Our ref: 10724
Council ref: MCU18/0221

10 August 2023

**RE: REQUEST TO CHANGE OTHER CHANGE APPLICATION (COUNCIL REF: MCU18/0221)
156-168 SERPENTINE CREEK ROAD, REDLAND BAY QLD 4165**

Figure 1: Sports, Recreation & Open Space Areas – Approved v Proposed (SHG)

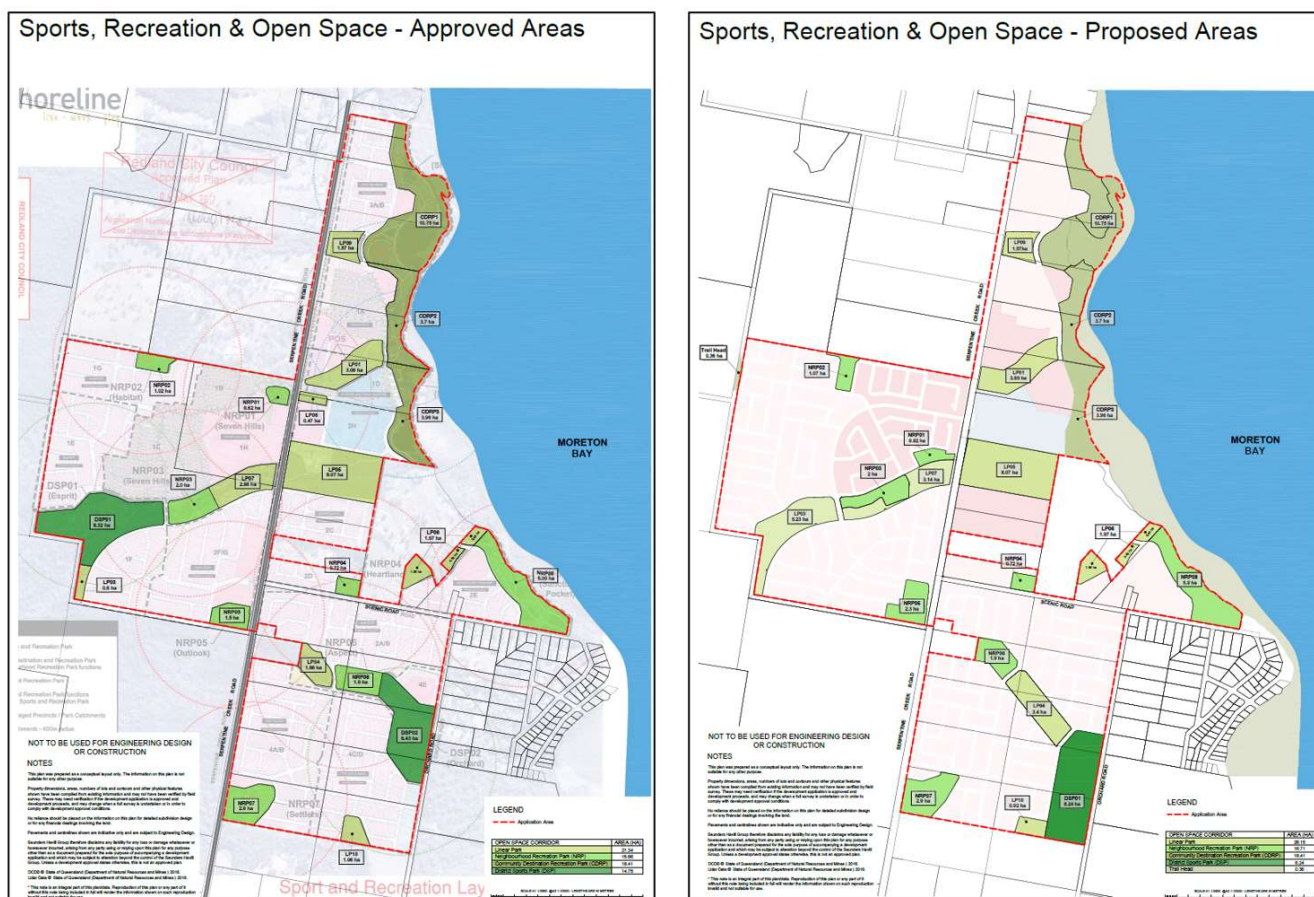
To determine the overall change to the open space corridors and establish where increases and decreases would occur, individual approved and proposed open space areas were reviewed and measured for accuracy. A comparison of approved and proposed open space areas was undertaken and has been summarised at the Sports, Recreation & Open Space Area Comparison (**Attachment O**), in **Figure 1**, over page, and at **Table 1**, below.

Open Space Type	Approved	Proposed	Change +/-
Linear Park	21.34ha	28.15ha	+6.81ha
Neighbourhood Recreation Park (NRP)	15.66ha	16.71ha	+1.05ha
Community Destination Recreation Park (CDRP)	18.41ha	18.41ha	0
District Sports Park	14.75ha	8.24ha	-6.51ha
Trailhead	0	0.36ha	+0.36ha
TOTAL	70.16ha	71.87ha	+1.71ha

Figure 2: District Sports Field Concept (SHG)

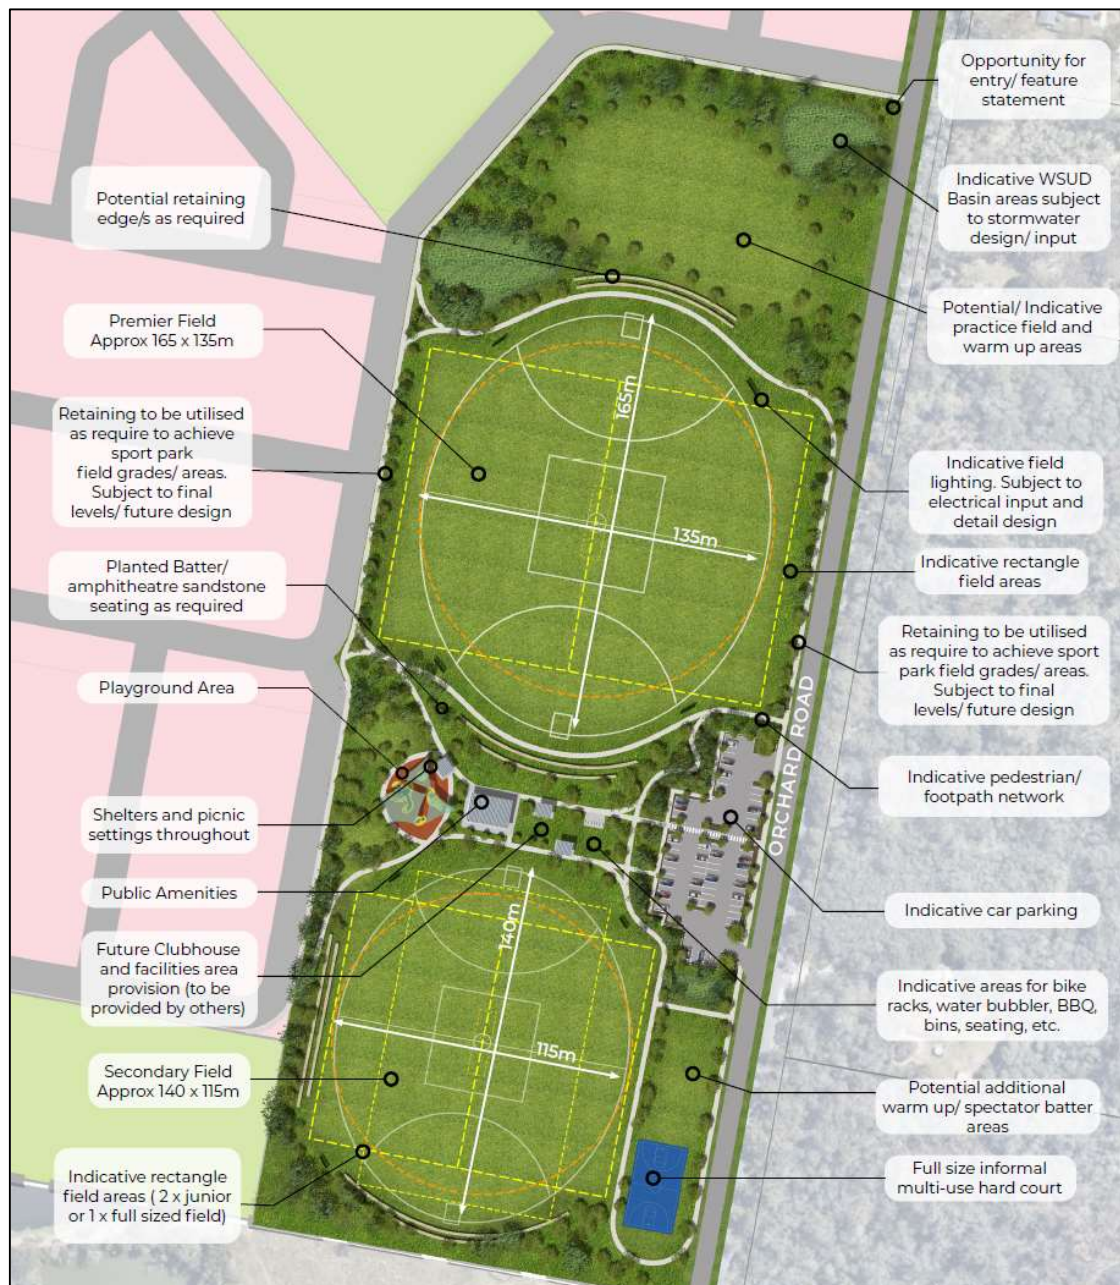
Conceptual sketches have been prepared which demonstrate the proposed level of service and embellishments and demonstrate compliance with Council's Draft Civic and Open Space Infrastructure Manual (COSIM) and Infrastructure Agreement (IA). Playing fields intend to be of a north-south orientation. The interface with adjoining residential lots has also been considered and it is noted that the consolidated DSP will adjoin a Residential Collector Street partially at the west, and it is anticipated that no rear boundaries or fences will adjoin the sports fields. The current conceptual sketches have flexibility for final sports types, whether they are ovals or rectangular multi purpose fields.

Refer also to the Sports, Recreation and Open Space Plan at **Attachment A**, the District Sports Field Concept at **Attachment G**, and to **Figures 2 and 3** on the following pages.

Figure 3: Approved vs Proposed District Sports Park Location/s (shown marked in red)

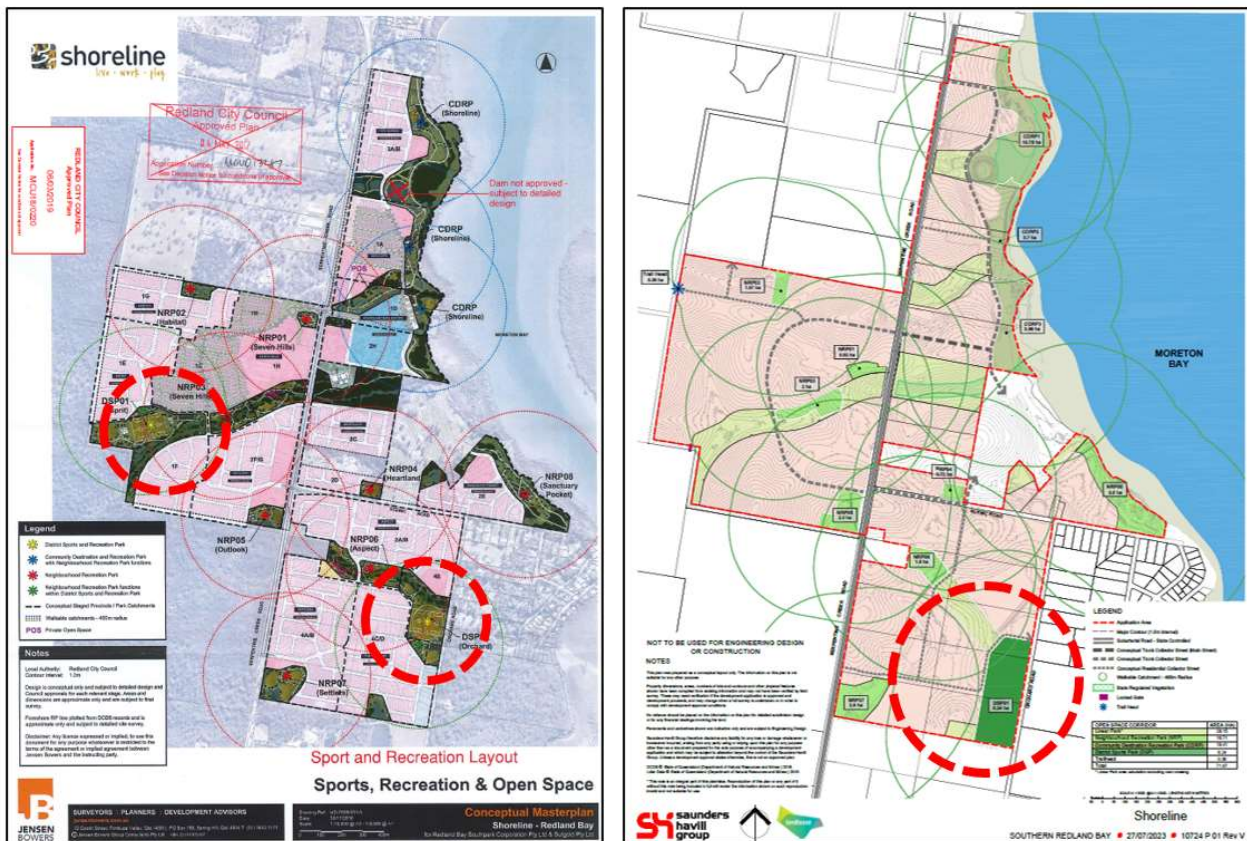
This application proposes to relocate DSP01 and consolidate this with DSP02, on Orchard Road. The proposed relocation provides the opportunity to form a single DSP that is appropriately sized and sited to service the locality. As the approved DSP02 is not required until the 3000th dwelling lot, the consolidation and delivery of a single DSP also provides the opportunity for a significant bring forward of the overall provision of sports facilities across the Shoreline development should this be desired.

The consolidated DSP concept has been relocated to the southeast corner of the estate to ensure the impacts of flooding are minimised and the area can be more useable. Other than a bioretention basin with a total area of approximately 300m², stormwater devices are positioned entirely outside of the DSP area. This redesign works to the site constraints to provide a resilient and functional open space area with better managed stormwater functions.

While the overall land area is reduced due to the removal of areas of constrained open space, the consolidated DSP will provide all DSS embellishments, including a combination of multi-purpose hard courts, sports fields, and playground areas that would have been provided under the current Preliminary Approval. The changes to the design have considered site topography and aim to avoid adverse visual impacts associated with retaining walls, which would have otherwise been required at the currently approved locations.

Figure 5: Approved vs Proposed Neighbourhood Recreation Park Locations (shown marked in red)

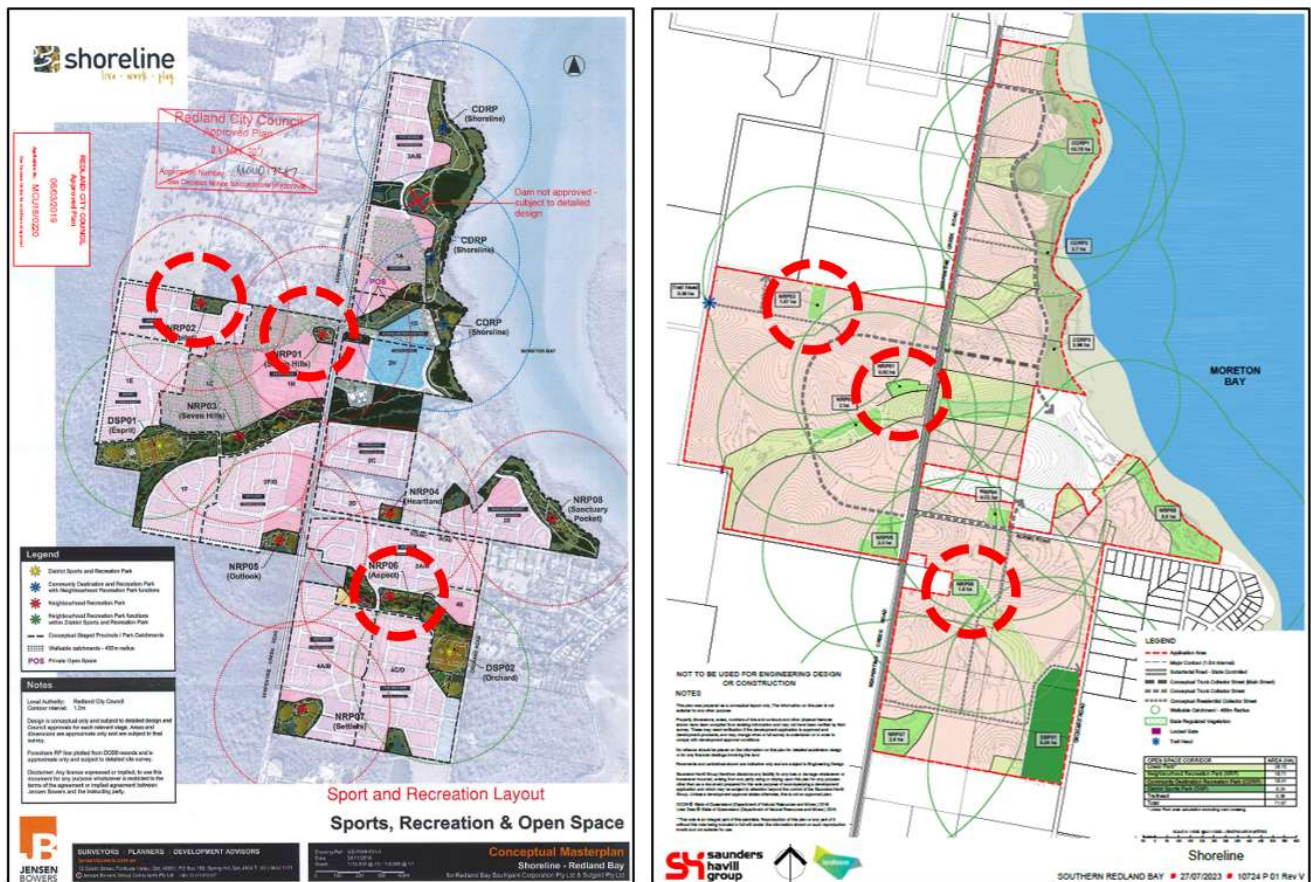
- Reposition NRP02 to provide a north / south orientation to increase road connectivity to the park and improve solar orientation;
- Reposition NRP01 and NRP03 to be co-located with the linear corridor to enable the protection of existing vegetation;
- Align NRP05 to be consistent with the existing development approval; and
- Reposition NRP06 west of the internal collector road to improve catchment access to the park and the efficiencies of the linear stormwater detention system.

Refer to **Figure 5, Attachment A** – Revised Shoreline Structure Plans and **Attachment F** – Neighbourhood Recreation Park Concept Sketches.

Figure 6: Approved (Council ref: MC18/0220) vs Proposed Masterplan

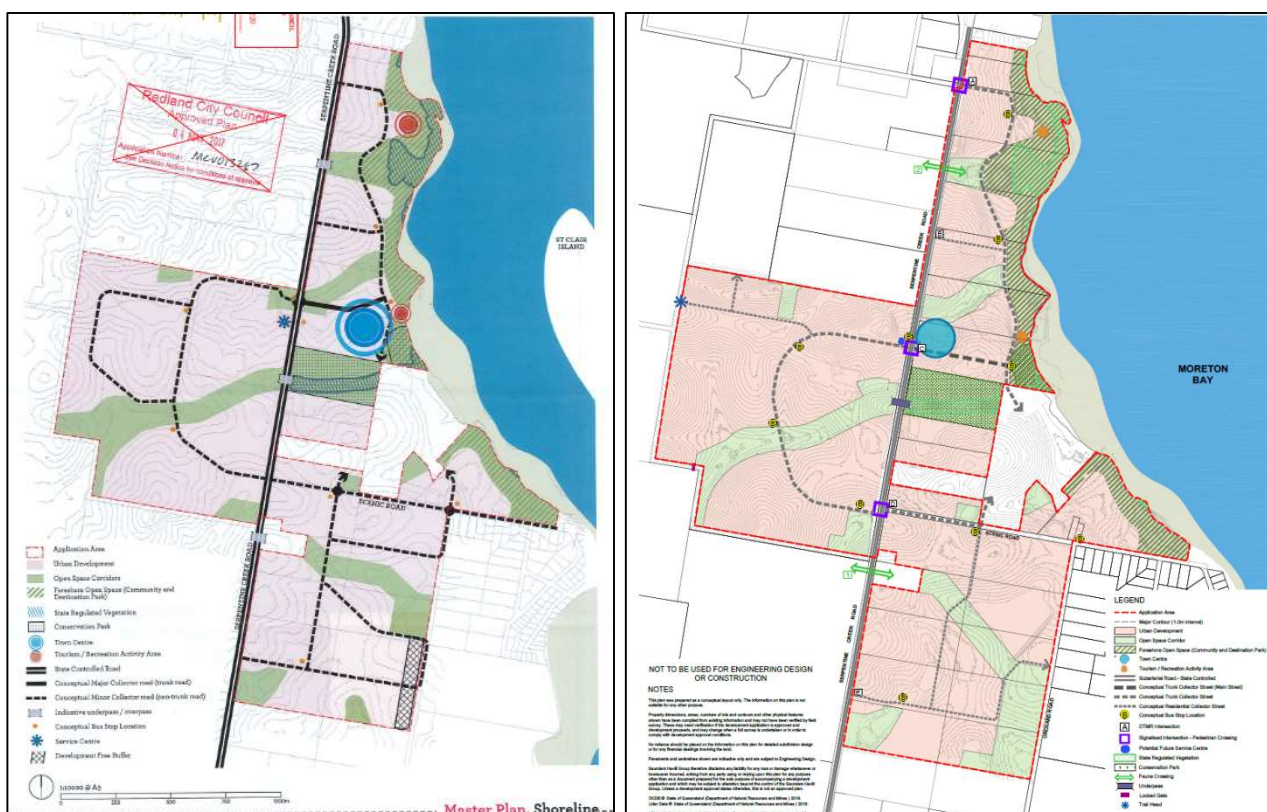
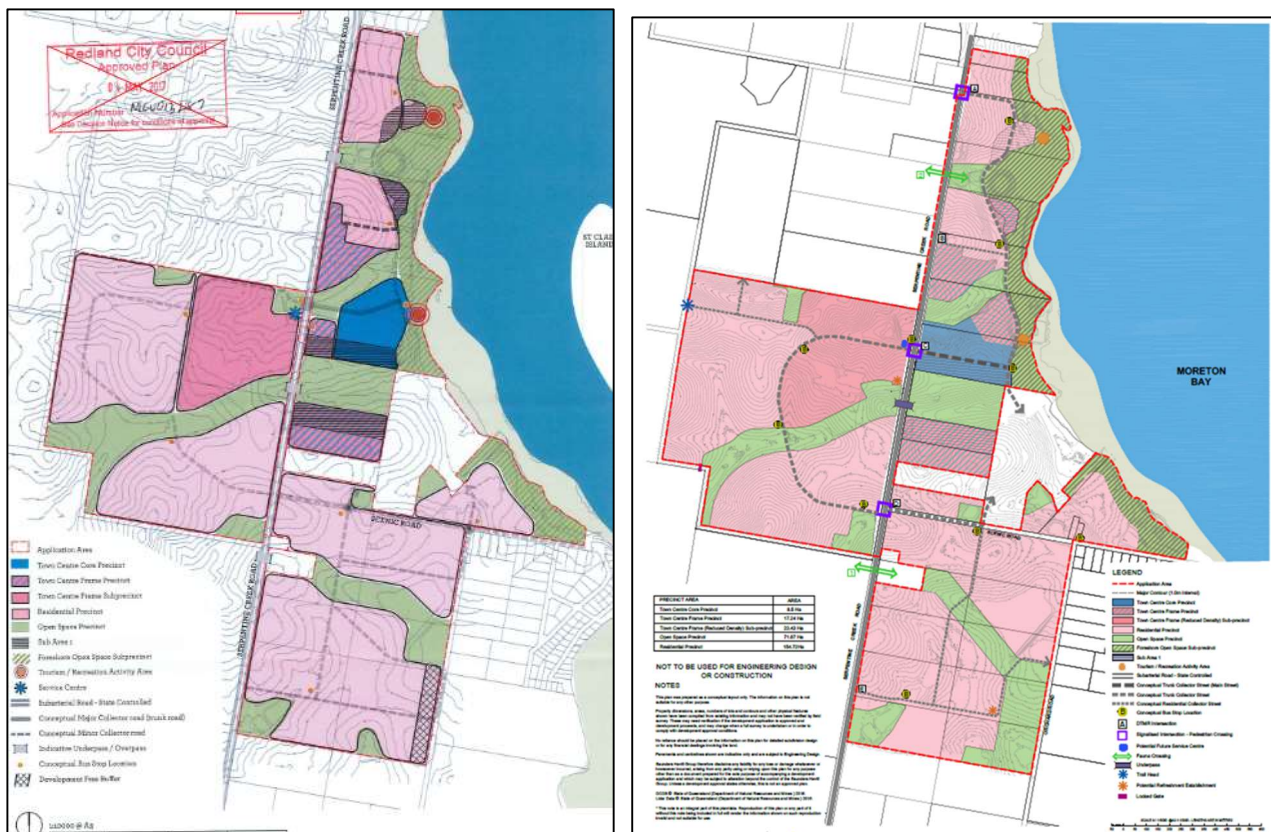
As a result of detailed master planning, this application seeks amendments to precinct boundaries for the Town Centre Core, Town Centre Frame, Town Centre Frame (Reduced Density) Sub-precinct and Residential Precincts, refer to **Attachment A**.

The change to the precincts was initiated through a detailed design of intersection C. The design identified a number of issues with the approved location and suggested moving the intersection south. The relocation of the intersection has the advantage of improving sight lines and allowing the discharge of stormwater in a less complex arrangement (the intersection was previously located at the low point of the land to the west). Refer to the Assessment of Transport Matters Advice at **Attachment K** for more detail.

The relocation of the intersection created an opportunity to reposition the Town Centre Core to address Serpentine Creek Road and allow future commercial uses increased access and visibility to the high order road, while providing the community with a true and identifiable Main Street. The repositioning also allows the Town Centre Core and Main Street to be opened up to Serpentine Creek Road by removing the visual separation of acoustic attenuation that was otherwise required at Serpentine Creek Road. Improved visibility and access provide greater long term retail viability and will ensure the provision of a vibrant town centre.

- **Figure 6**, which provides a comparison of the approved and proposed Masterplan;
- **Figure 7**, which provides a comparison of the approved and proposed Precinct Plan; and
- **Attachment A** – Revised Shoreline Structure Plans.

Figure 8: Approved (Council ref: MCU18/0220) vs Proposed Conceptual Road Hierarchy Plan

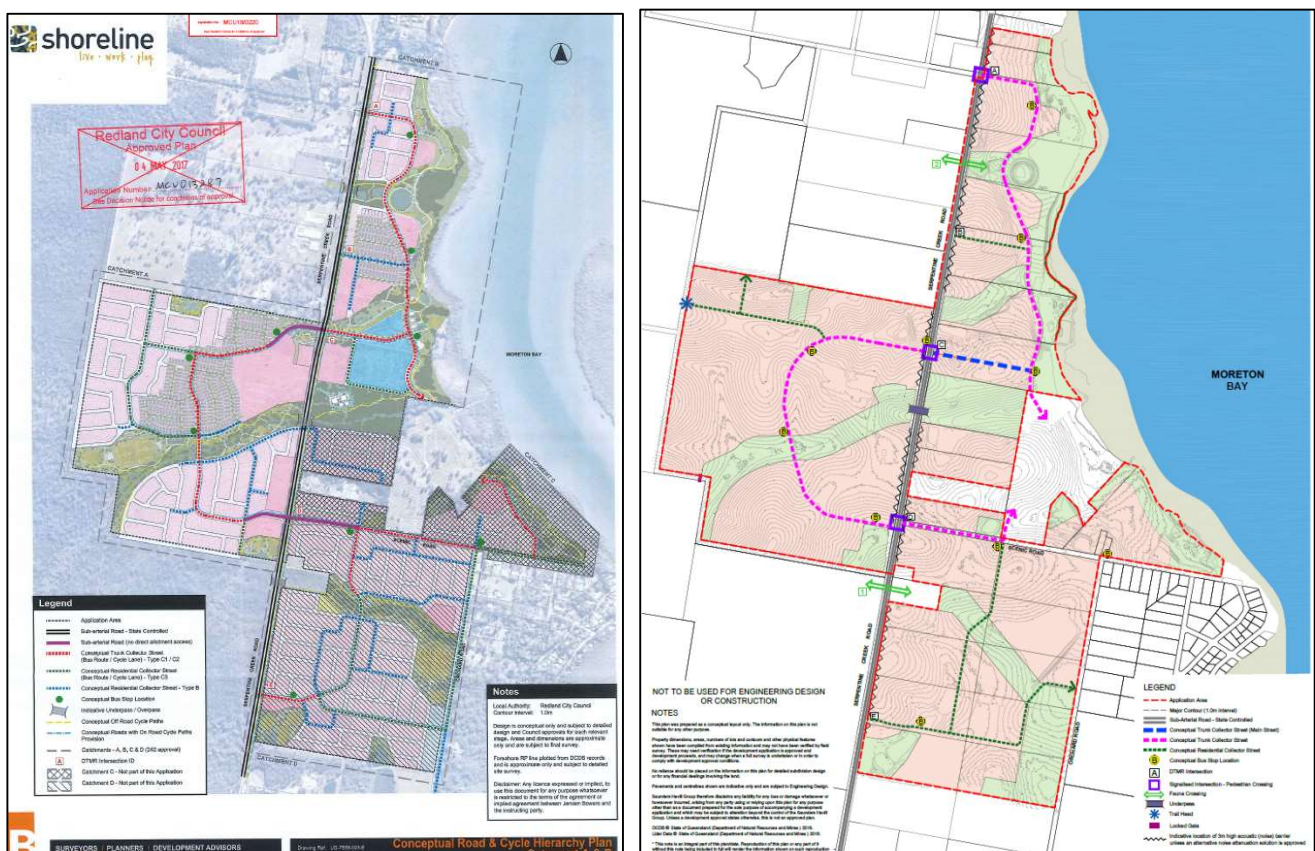
- Repositioning of the signalised intersection C approximately 150m south to improve visibility, sightlines, constructability and stormwater management;

- Changed alignment of conceptual major collector roads (trunk road) and conceptual residential collector roads together with associated changes to the footpath and cycleway networks;

The Conceptual Road and Cycle Hierarchy Plan and the Active Transport Network Plan focus on the conceptual layout of the intended road networks including on-road cycle paths and have been amended to reflect the required changes to connectivity to and within the estate. Refer to the Conceptual Road and Cycle Hierarchy Plan and the Active Transport Network Plan at **Attachment A** and to **Figures 8 and 9** which provide a comparison of both the approved and proposed plans.

Figure 9: Approved (Council ref: MCU18/0220) vs Proposed Active Transport Network Plan

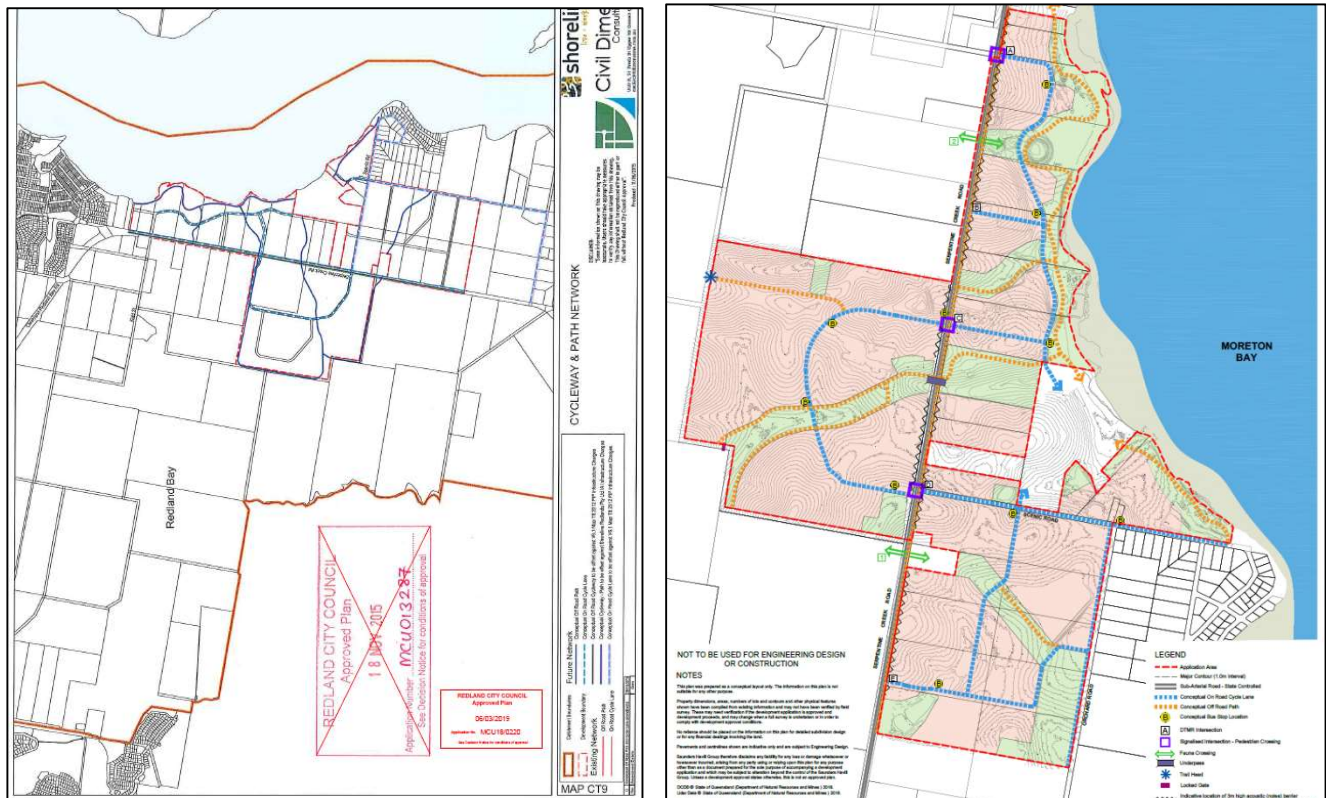
- Facilitating strengthened east-west connections for cyclists, specifically from intersection E which will connect Serpentine Creek Road to Orchard Road, establishing the southern cyclist connections (refer also to **Figure 9**).

Noting the significance of the incompatibility, this application seeks to amend the approved conceptual location to ensure that consistency with the conditions of approval can be maintained. The proposed off road path has consequently been realigned to the north of the lot. This will ensure that future works associated with the connection can avoid impacting RARP Areas and habitat values, and without compromising the extent of future areas to be dedicated for conservation purposes. It is acknowledged that the preliminary approval has focussed heavily on the facilitation of movement within and beyond the estate,

Refer also to **Figure 9** and the Active Transport Network Plan at **Attachment A**.
